Project:
Proposed Development at Land to Rear of 25-27 Perrymount
Road, Haywards Heath

PROJECT
CENTRAL HOUSE WESTERN ANNEX
BUILDING, HAYWARDS HEATH

DRAWING TITLE
PROPOSED BELOW GROUND DRAINAGE
SITE PLAN

DM/26/0496 - Land To The R/o Central House, 25 Perrymount Road, Haywards Heath, West Sussex RH16 3XL

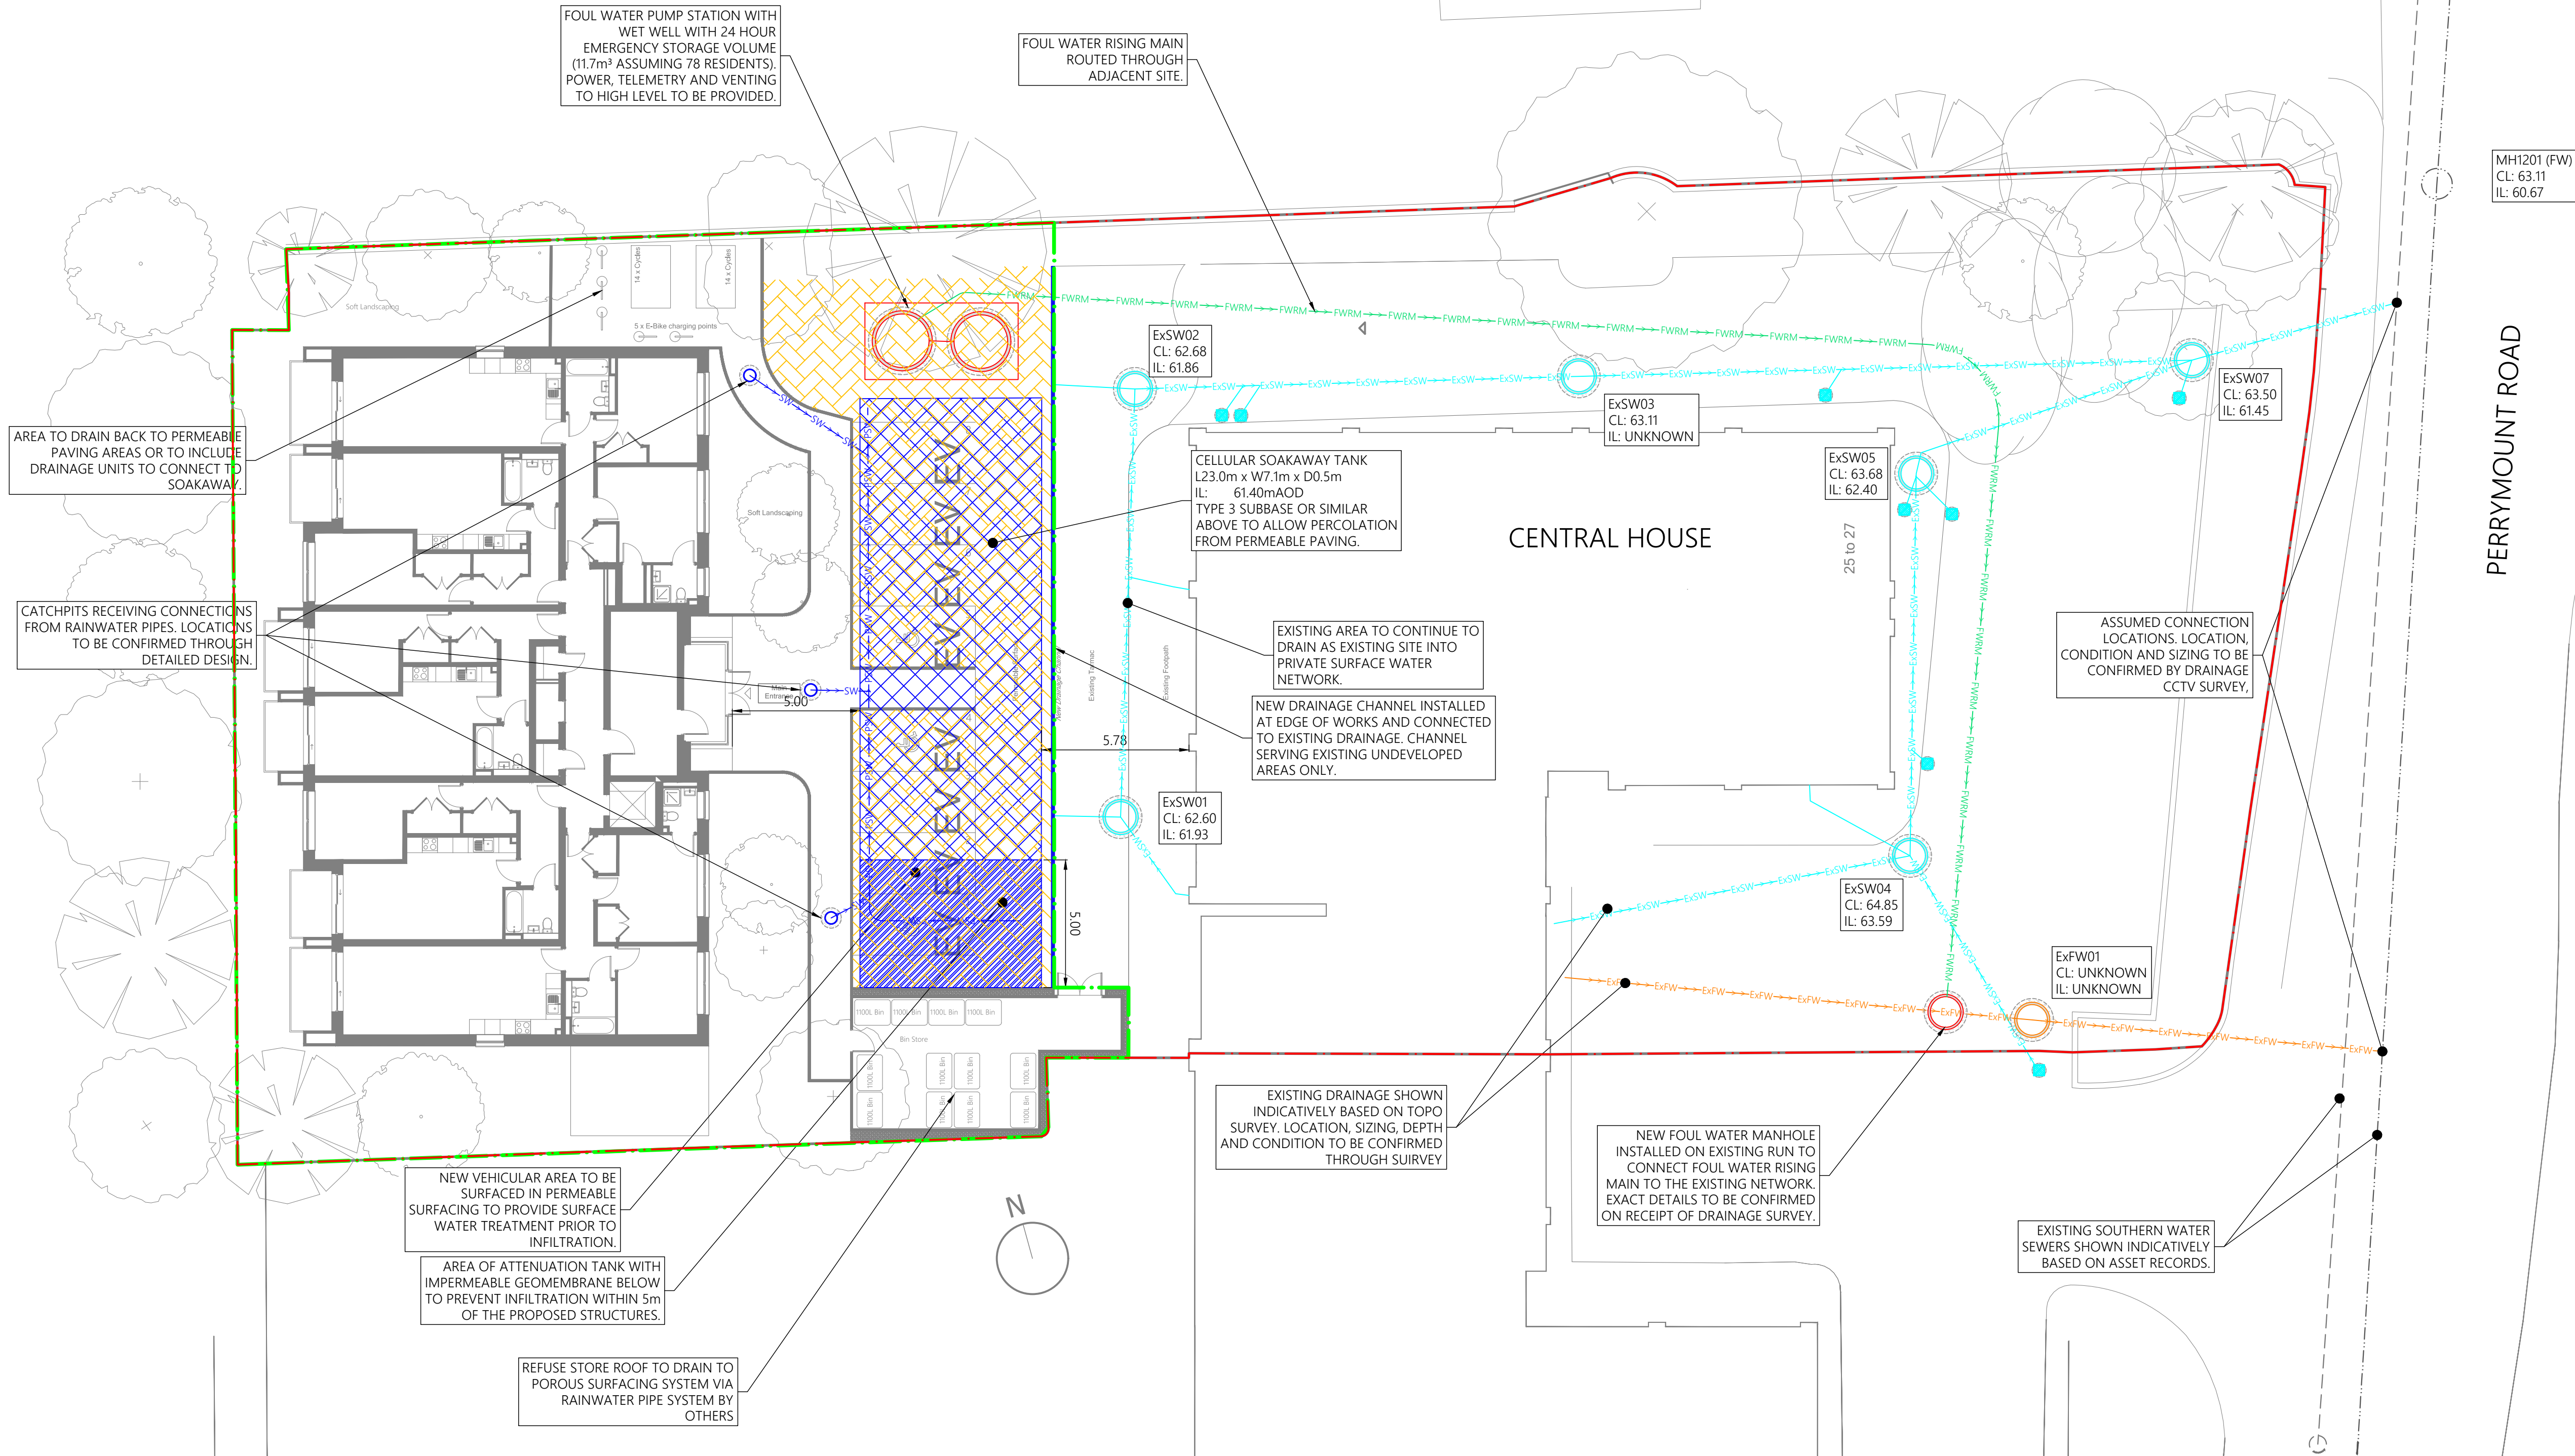
The LLFA object to this application. We are concerned over the level of detailed information with respect to the surface water drainage strategy. We accept that the FRA is acceptable and proportional to the application.

1. A sufficiently Detail Design plan that caters for the 1 in 100-year, plus 45% climate change storm event and follows the drainage hierarchy.
2. Evidence that a suitability sized surface water drainage system can be located on the site considering site constraints, including adjacent development's utilities and drainage.
3. Up to date CCTV/Drainage Survey may be required to demonstrate viability of any solution.
4. If discharge to a public sewer be proposed then the following information will be required:
 - I. Evidence that alternative more sustainable means have been considered
 - II. Evidence that Southern Water have agreed, in principle, to such a connection will be
 - III. Evidence that no pumped system is proposed.

- IV. Evidence that any discharge off site is limited to the Greenfield QBar runoff rate for the area being drained or Evidence that Southern Water has set a suitable discharge rate for the development to utilise.
5. All supporting hydraulic calculations are submitted using the current standards e.g **FEH22**, CV = 1 (both summer and winter), at the required rainfall scenarios and demonstrating no flooding within the site at the 1 in 30.
